**ADDENDUM NO. 1
FEBRUARY 26TH, 2026**

PROJECT: ANSON ISD
ELEMENTARY & HIGH SCHOOL CLASSROOM ADDITION

BID DATE: MARCH 5TH, 2026

NO.	REVISION	DATE	PROJECT #	SCALE	BAR IS ONE INCH IN LENGTH ON ORIGINAL DRAWING. CHECK SCALE AND ADJUST ACCORDINGLY.
1	ADDENDUM 1	2/26/26	25320	1/8" = 1'-0"	
SEQ.	SHEET		151.0

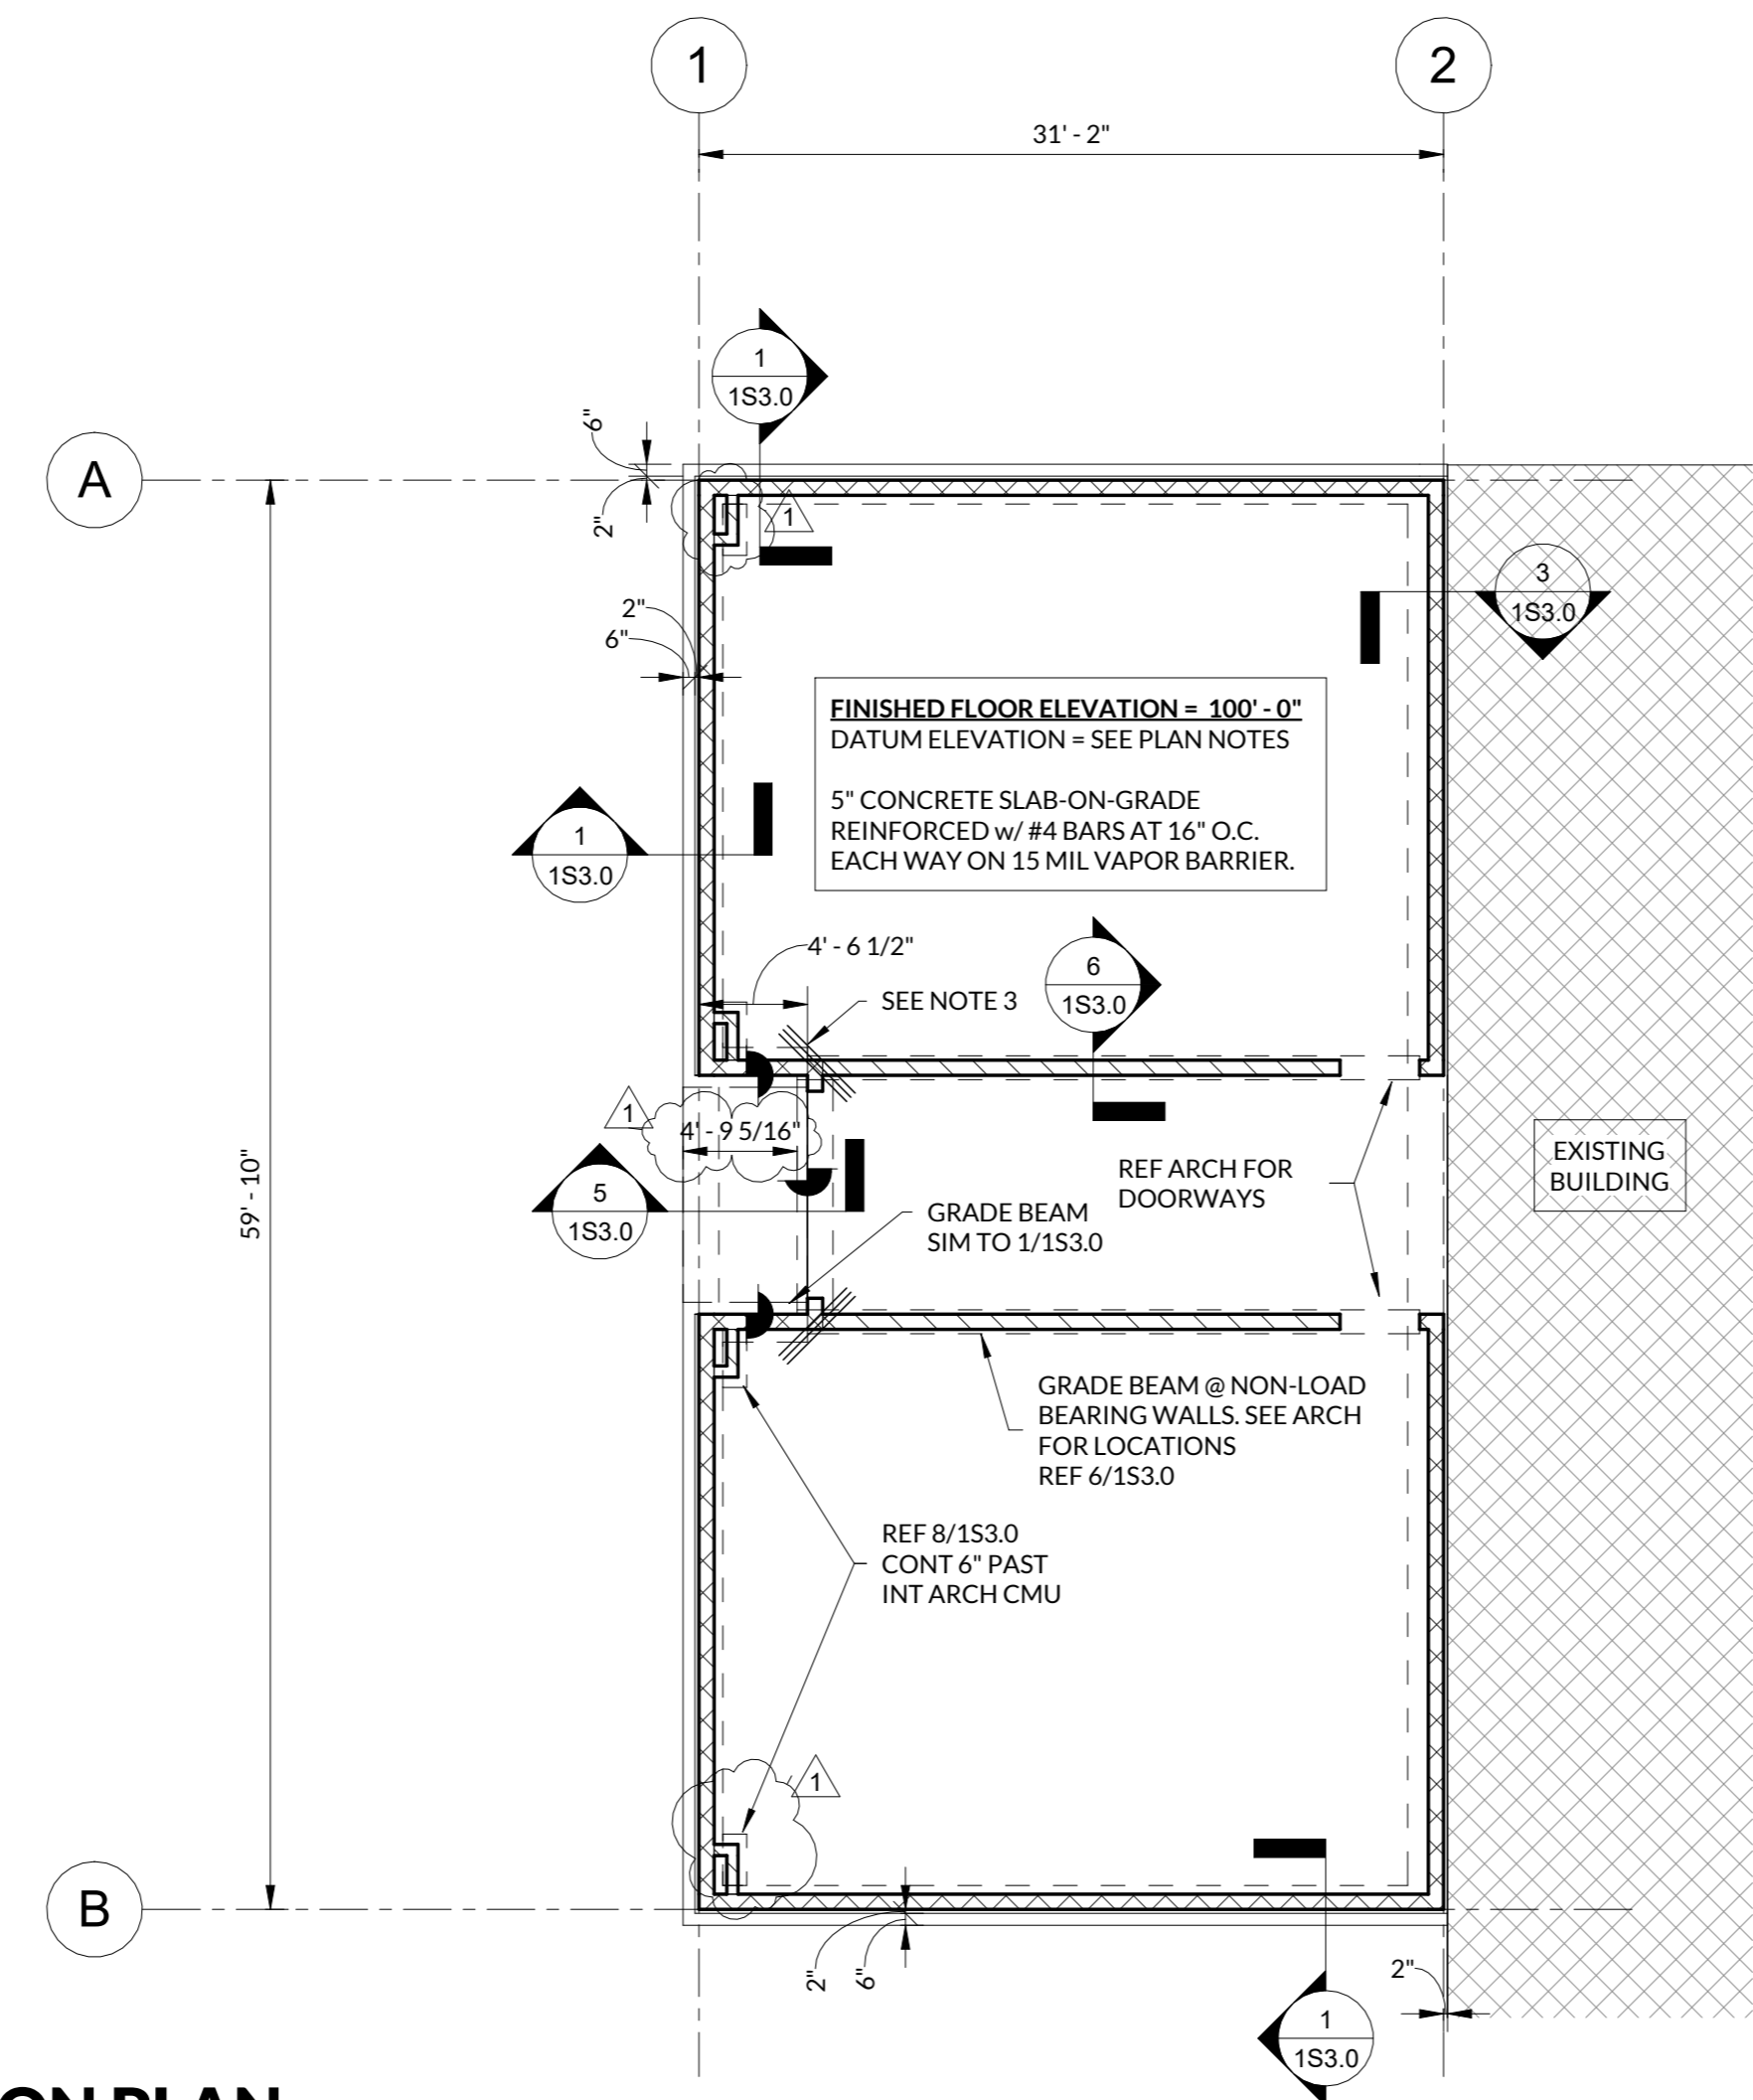
- Item #D1** **Sheet 1A2.1** – REPLACE sheet with attached sheet 1A2.1 dated 02-26-2026. UPDATED room finish schedule ceiling heights.
- Item #D2** **Sheet 1A5.0** – REPLACE sheet with attached sheet 1A5.0 dated 02-26-2026. UPDATED wall sections showing raised top of steel & lowered ceiling heights.
- Item #D3** **Sheet 1A7.0** – REPLACE sheet with attached sheet 1A7.0 dated 02-26-2026. UPDATED reflected ceiling plan with updated lighting layout in Vest. 100 & ceiling heights.
- Item #D4** **Sheet 1S1.0** – REPLACE sheet with attached sheet 1S1.0 dated 02-26-2026. UPDATED plan with missing non-load bearing CMU walls & added dimensions.

1 ROOF FRAMING PLAN
 SCALE: 1/8" = 1'-0"

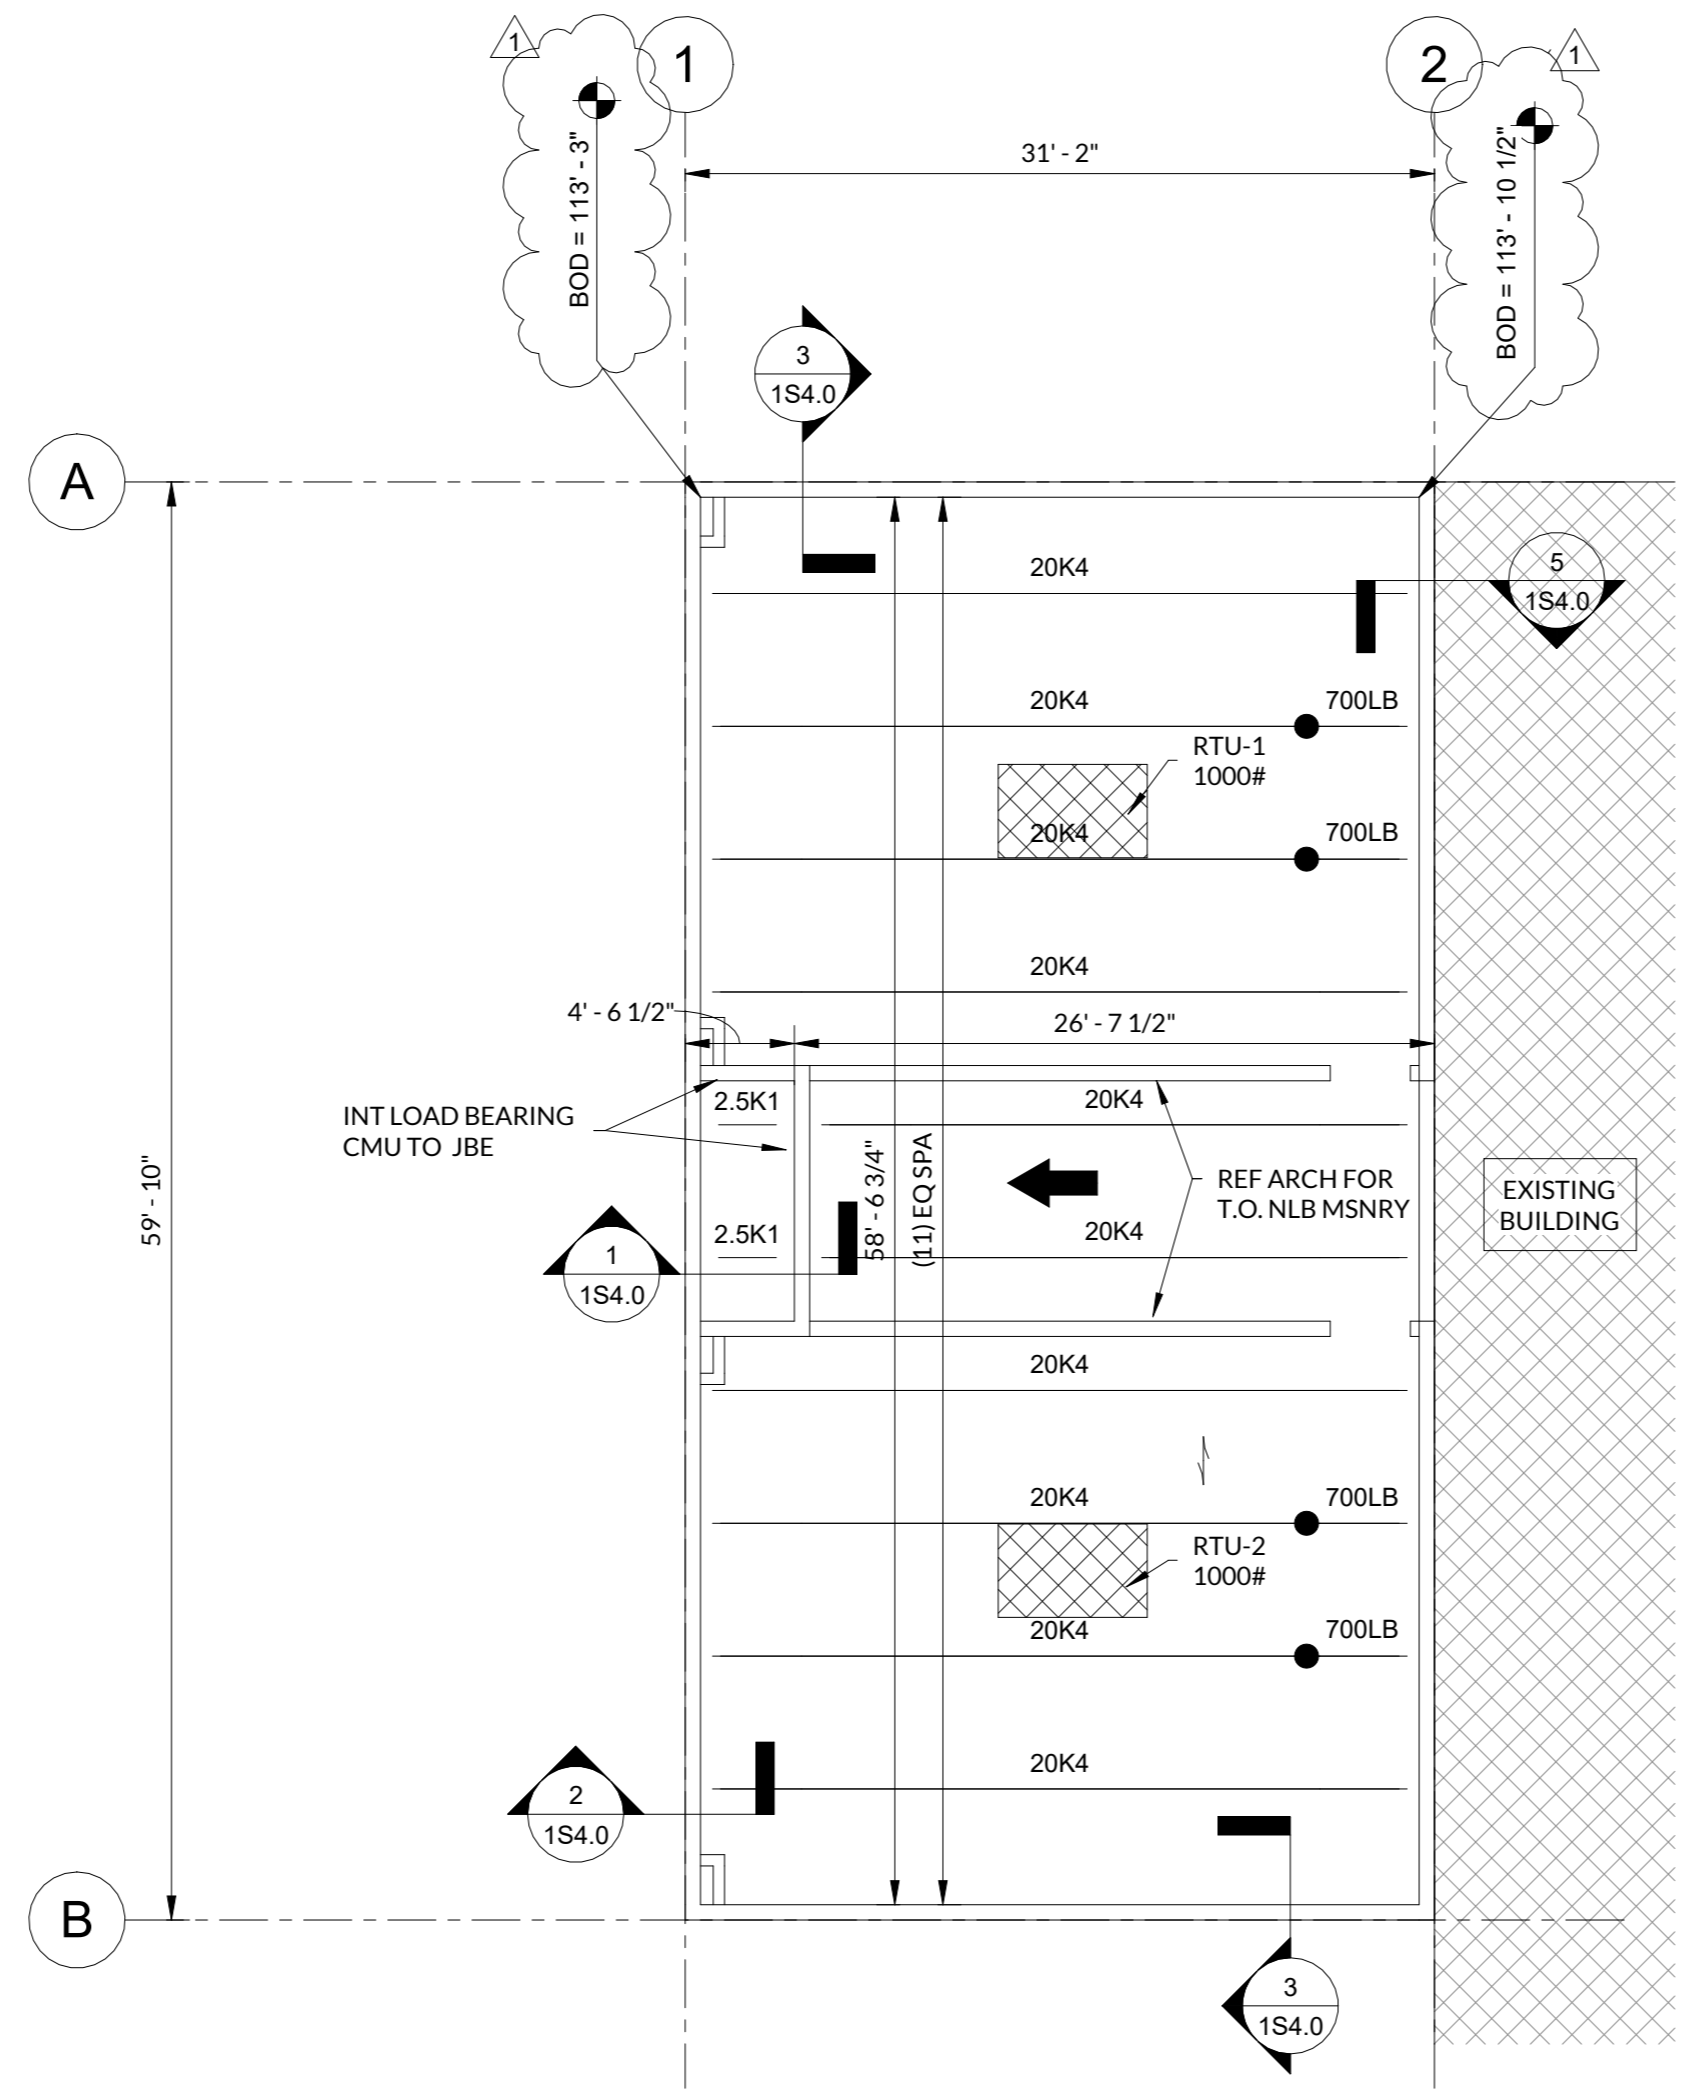
- Item #D5** **Sheet 1S2.0** – REPLACE sheet with attached sheet 1S2.0 dated 02-26-2026. REVISED bottom of deck elevations.
- Item #D6** **Sheet 1S4.0** – REPLACE sheet with attached sheet 1S4.0 dated 02-26-2026. REVISED framing details.
